**Re:** Demolition of 6 storey office building and basement. Construction of mixed use development ranging from 9 to 17 storey's in height and site development works. An EIAR and NIS submitted with planning application.  
CitiGroup Building, 1 North Wall Quay, Dublin 1, D01 T8Y1

**RE: Additional response submission in relation to ABP Case Reference PL29N.319719  
(DCC Planning Reference 3274/24) at 1 North Wall Quay, Dublin 1, DO1 T8Y1**

# 1NWQ, Dublin 1

Response to points raised in the Third Party Appeal by CQMC with regards to the Daylight, Sunlight & Overshadowing Assessment

20340-1NWQ-BPC-XX-ZZ-M3-P13-01  
EXISTING-21-Mar 09-00

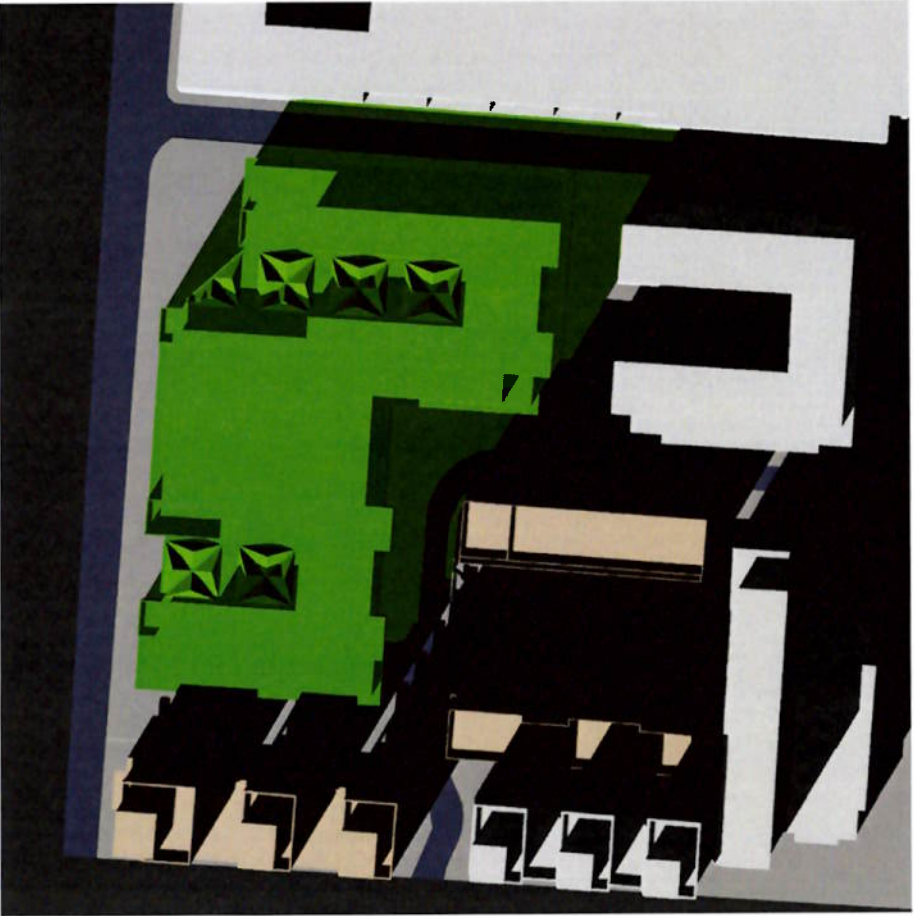
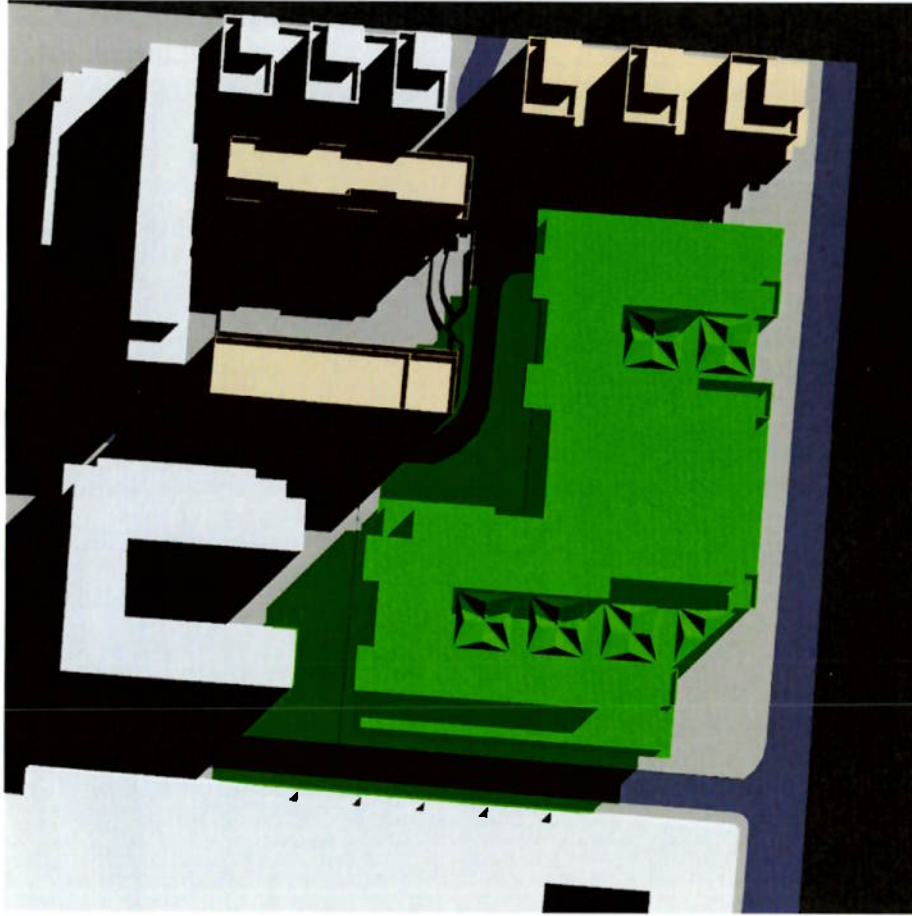
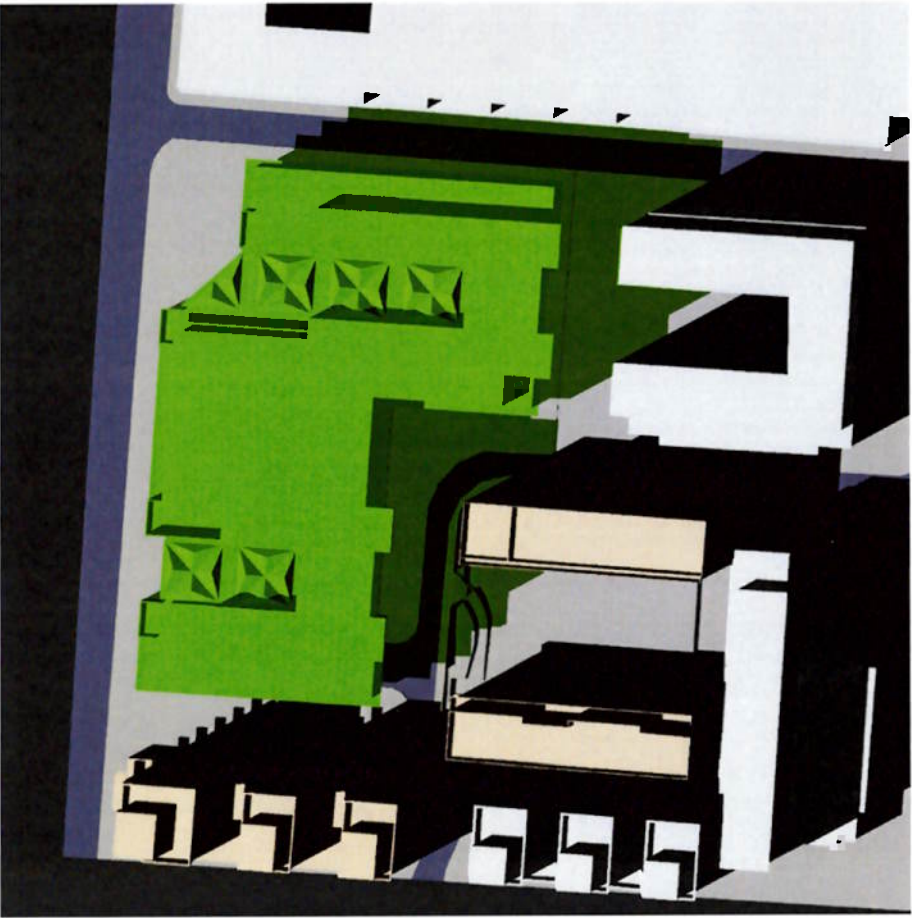
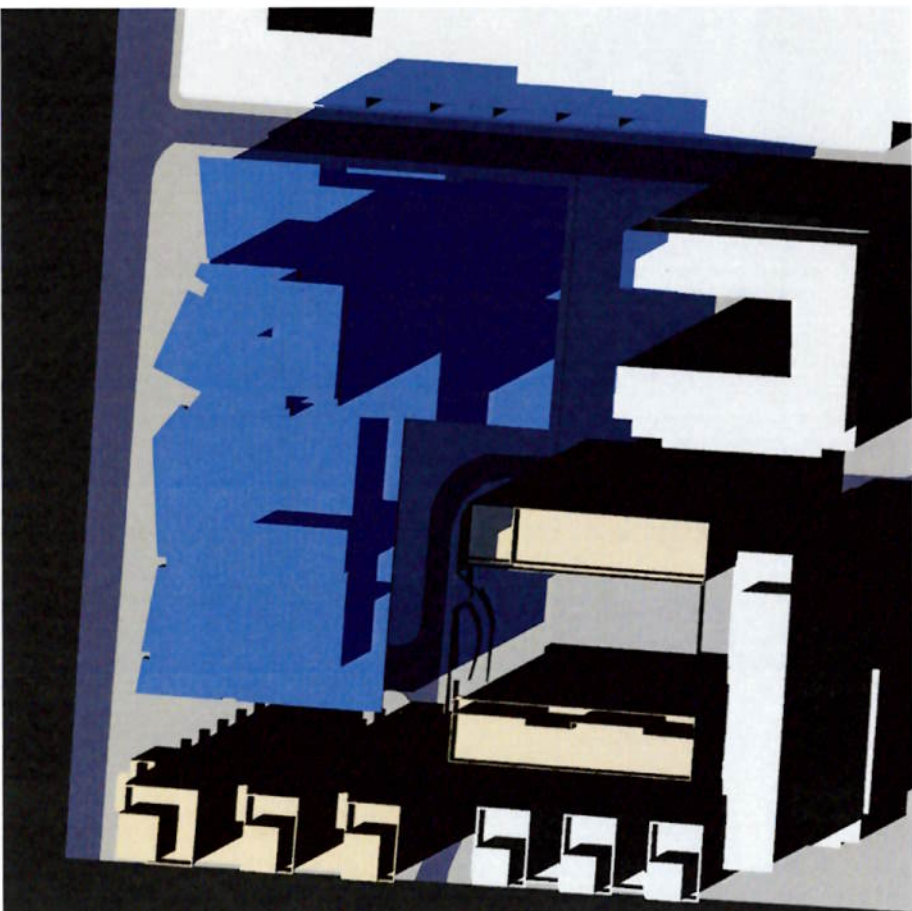
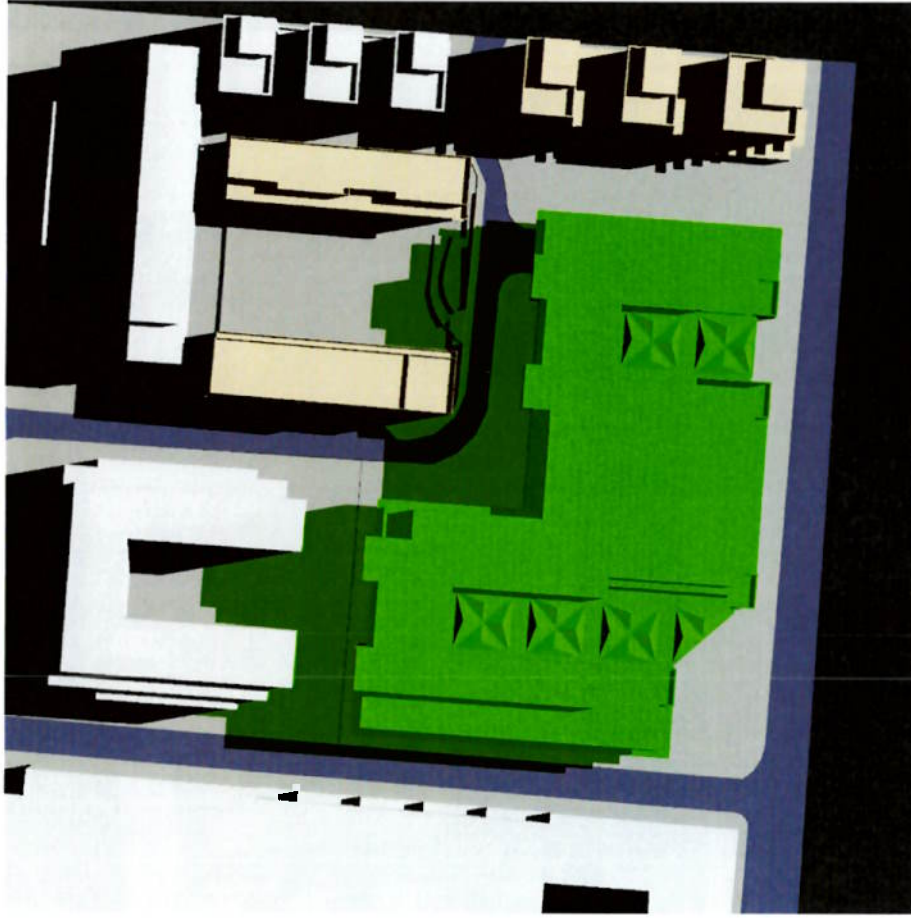
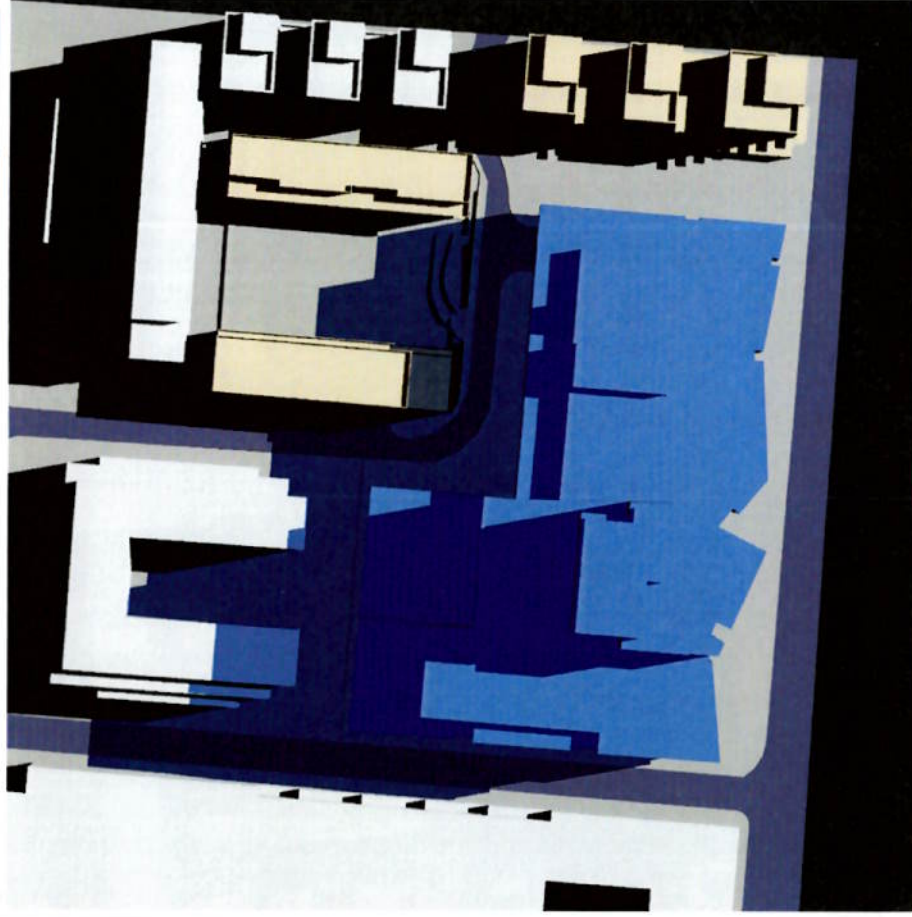
The shadow diagrams which are included in the Appendix to the Daylight, Sunlight and Overshadowing Assessment provide data for the 21<sup>st</sup> of March, June, September, and December. The results given are for increments of every 2 hours per day. An hourly breakdown would be more informative. The computational models of the existing building, the proposed development and the surroundings used are lacking in detail and appear to be missing some plant and screening elements which are critical to the assessment of potential obstruction. The model of the building generated for the solar gains study is considerably more detailed.

The appeal raised by CQMC requests shadow images on an hourly basis. While this is not a requirement, we have included these images as Appendix A for March and June 21st. The images show some additional shadows cast on March 21st due to the proposed development, but this is limited predominantly to the time between 12 and 2 o'clock. Its important to note on June 21st when the amenity area is used most frequently the proposed building does not cast any significant amount of shadow on the neighbouring amenity. The proposed design has gone through a series of design iterations to ensure there is not a significant effect by the proposed development on the neighbouring amenity and the shadow analysis along with the sunlight analysis on March 21st verifies this.
